ADDENDUM NO. 03
 May 12, 2009

Project: Three Elementary School Additions/Renovations
 Texas City Independent School District

Bay Project No.: 0750, 0754 & 0755

S4.1
 CONCRETE DETAILS
 PART B
 PART 'B' HEIGHTS

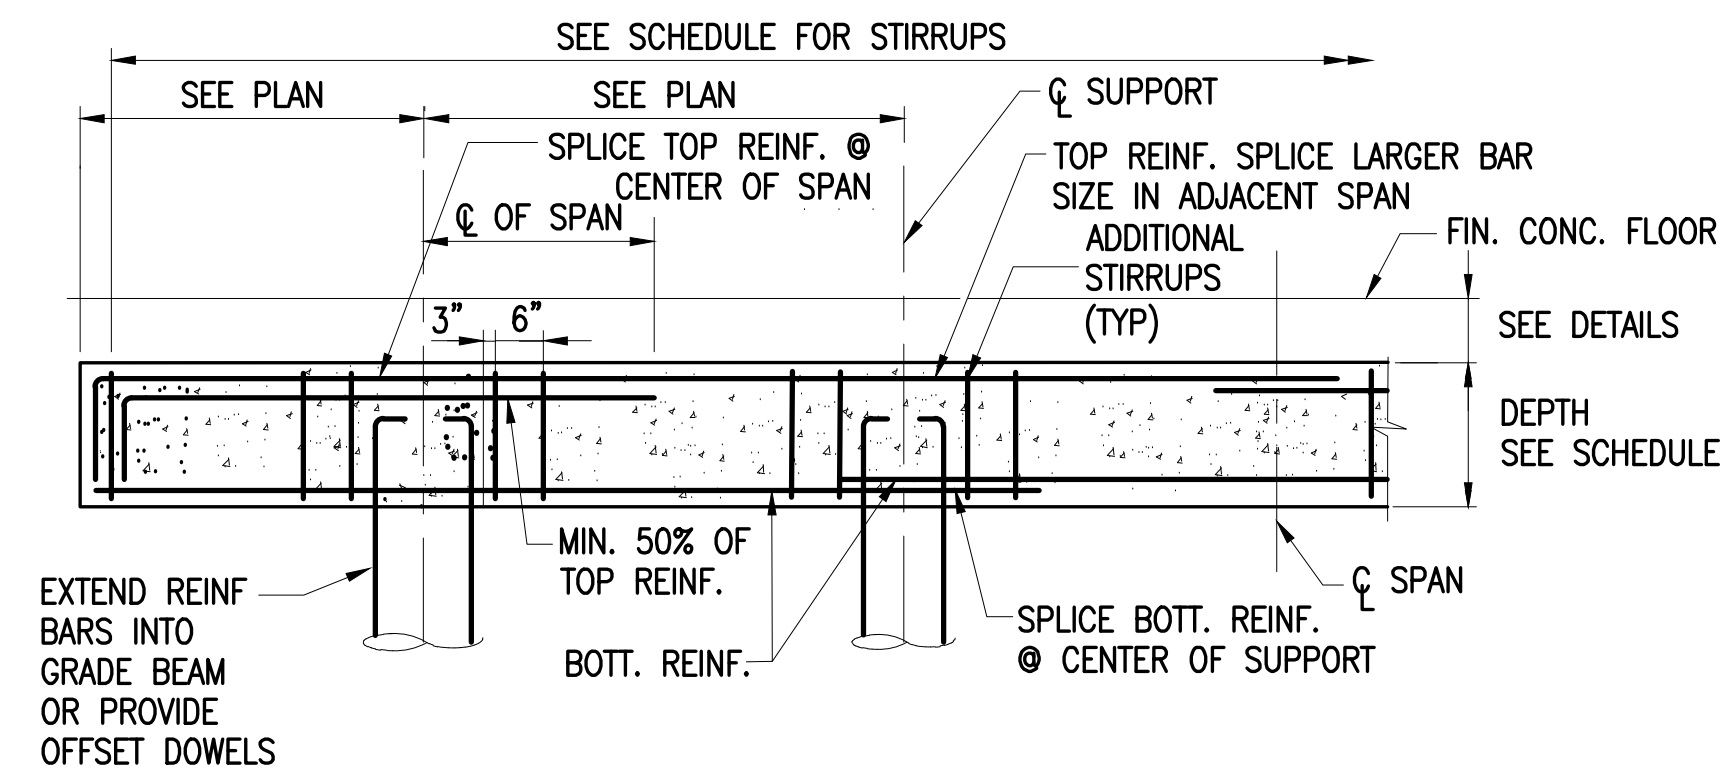
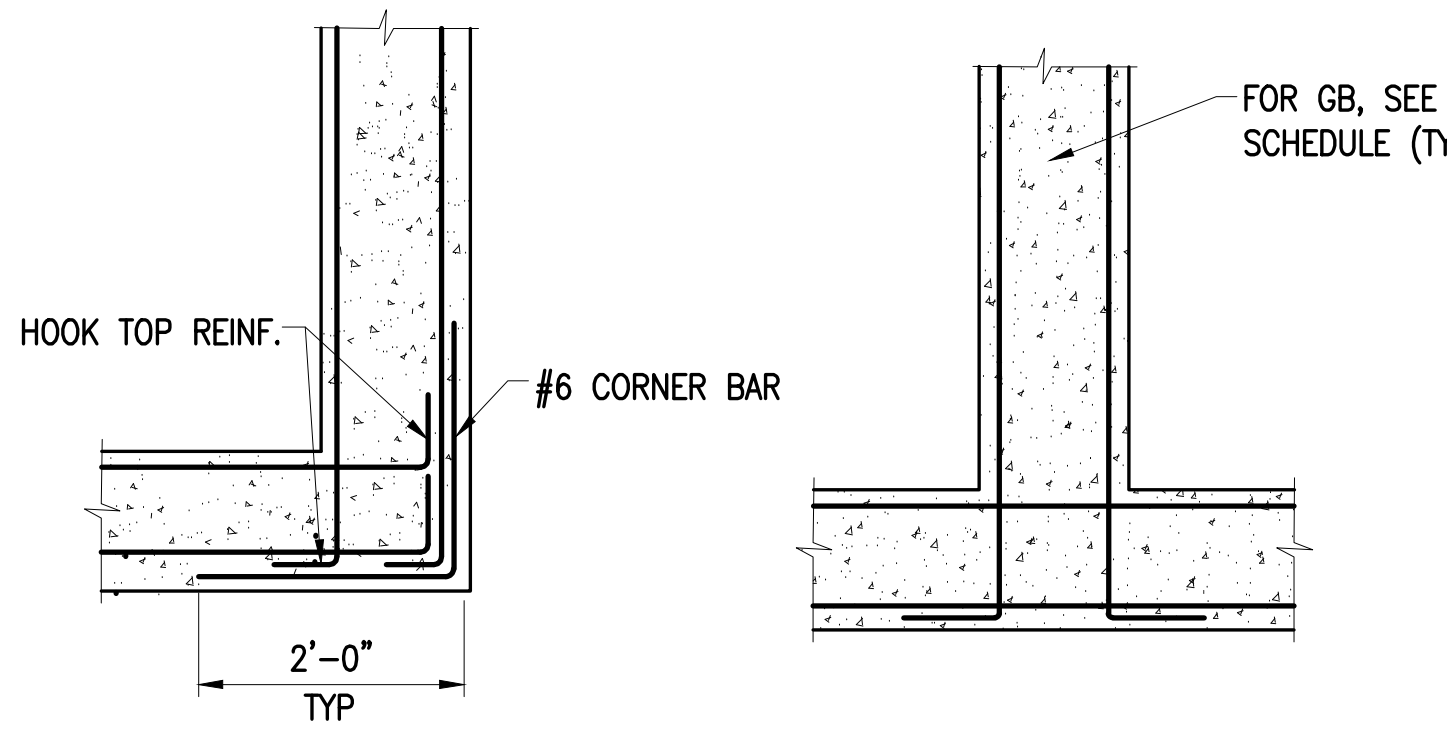
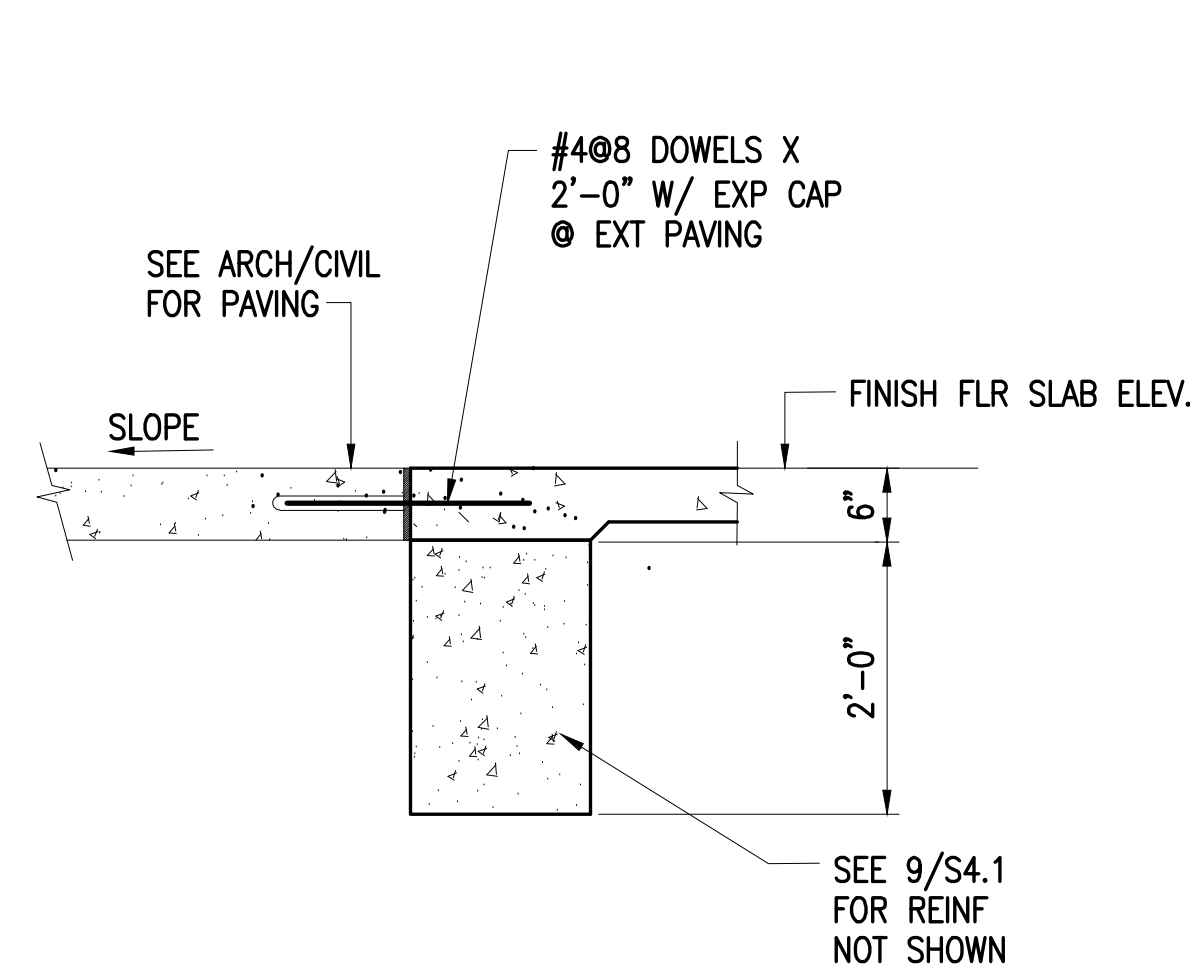
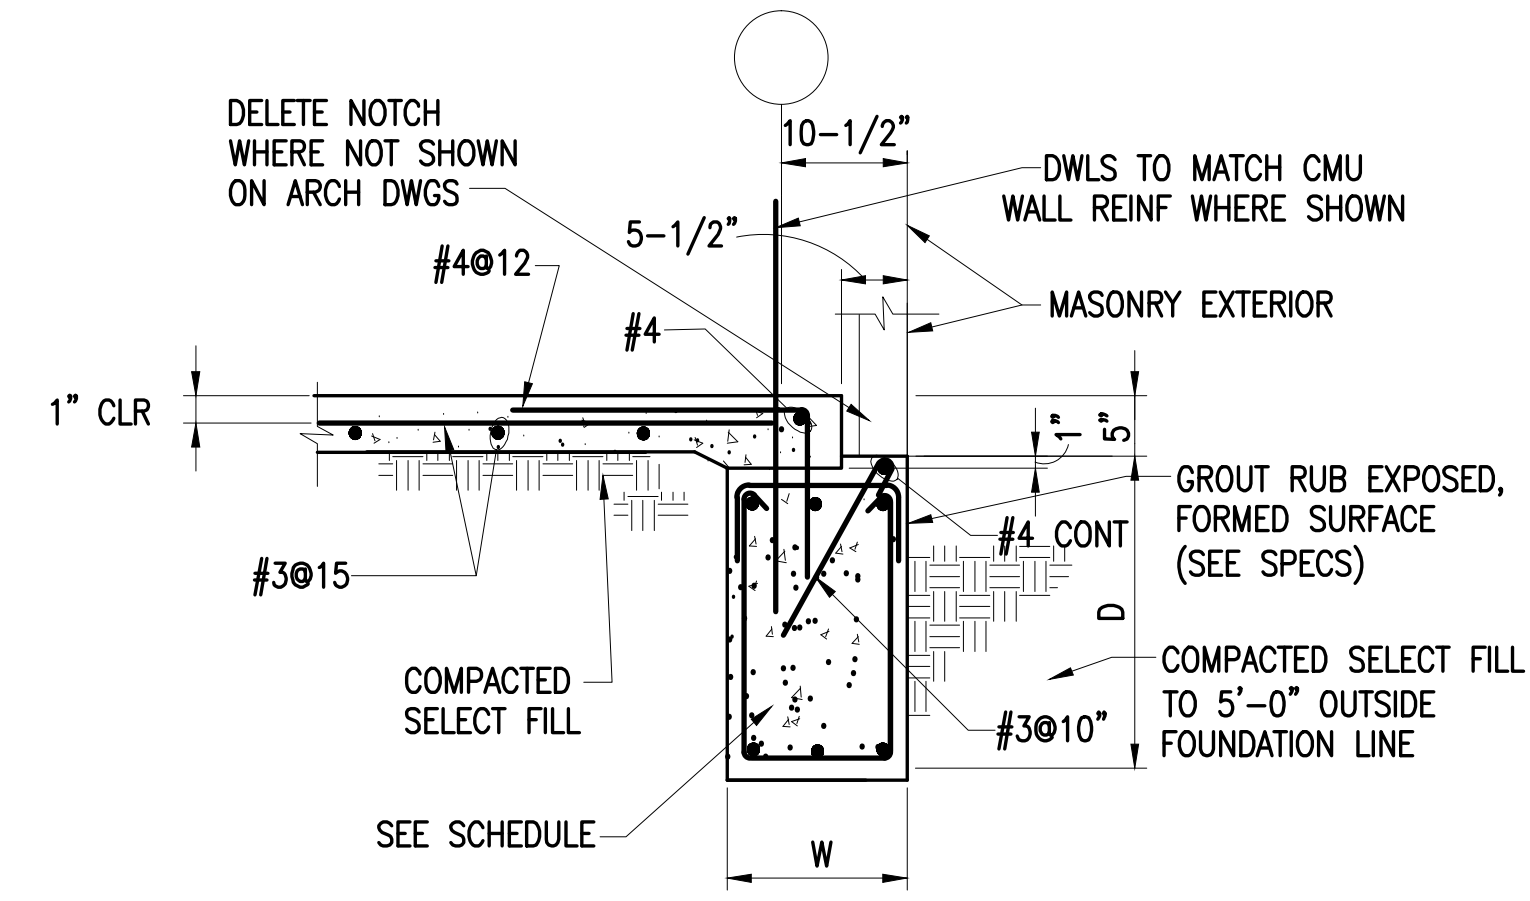
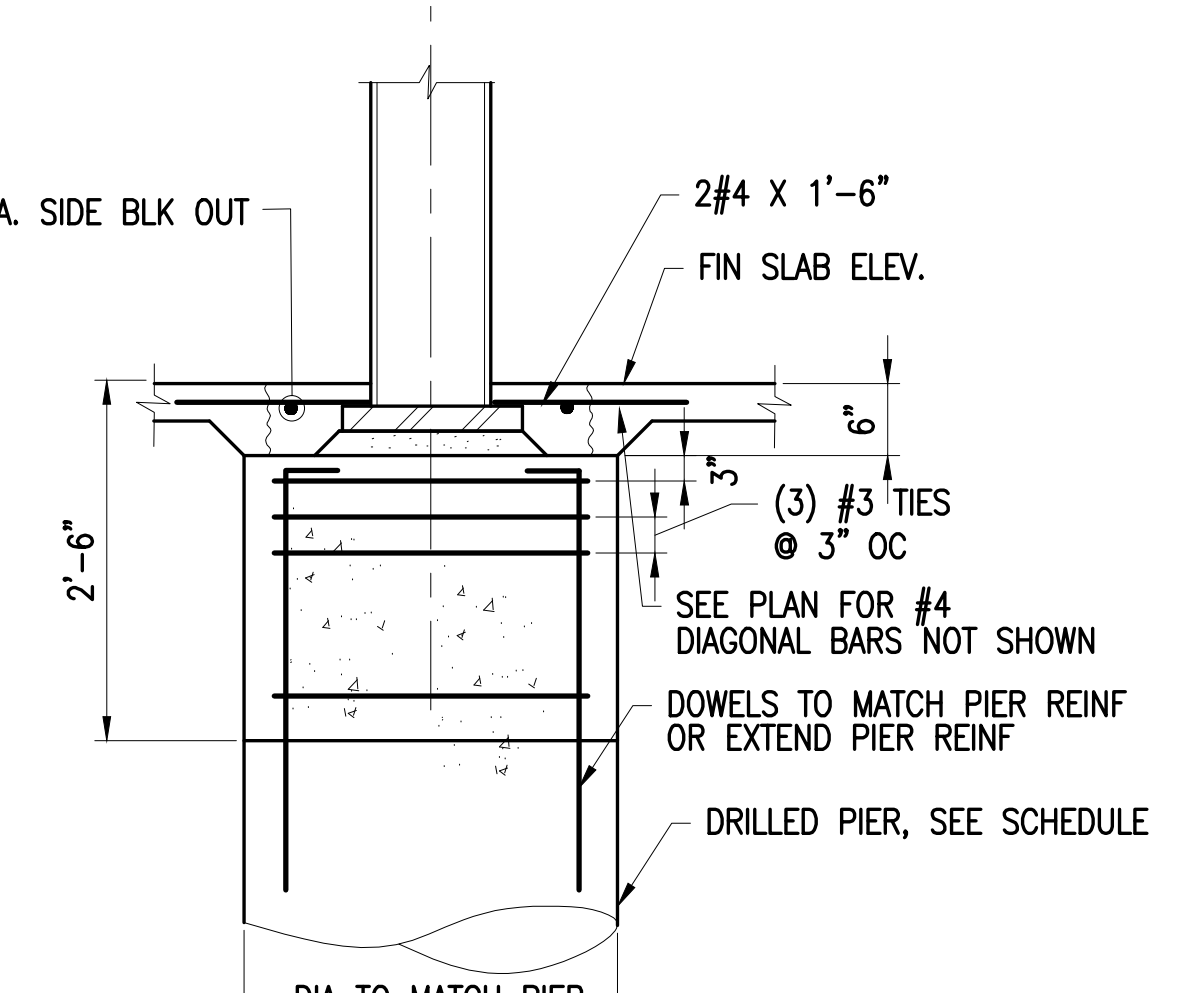
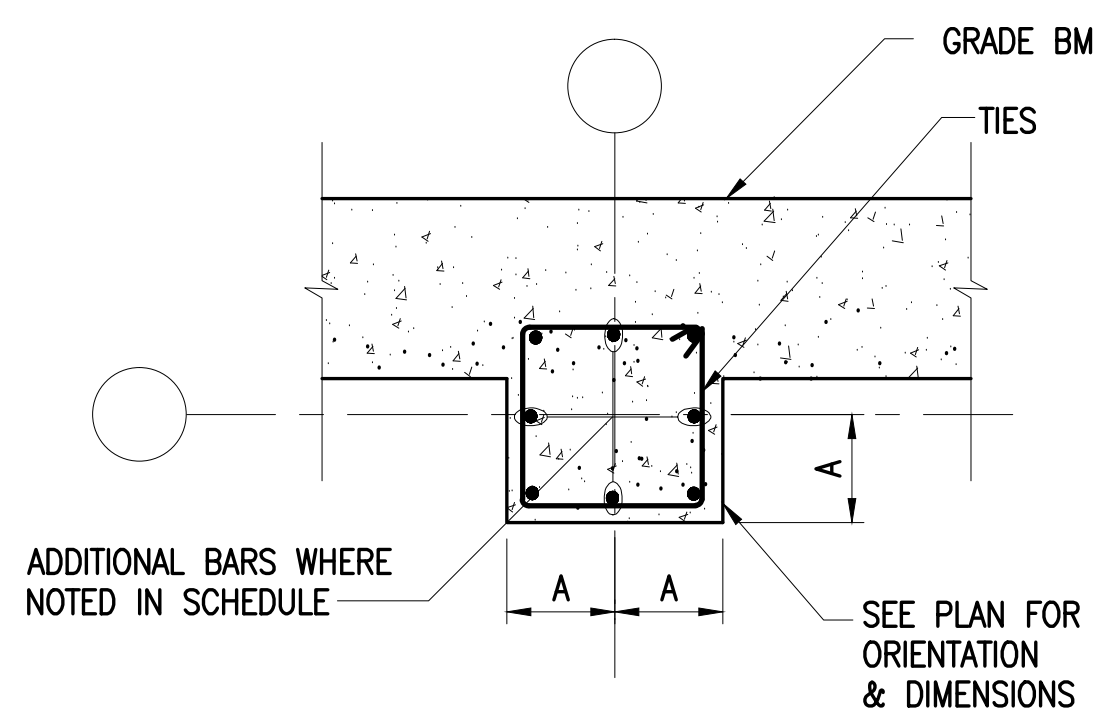
10. Sheet S4.1 Concrete Details, Part B
- a. Delete Drawing S4.1 dated March 11, 2009, "Bid Set" and substitute new drawing S4.1 dated May 12, 2009, Addendum 3.
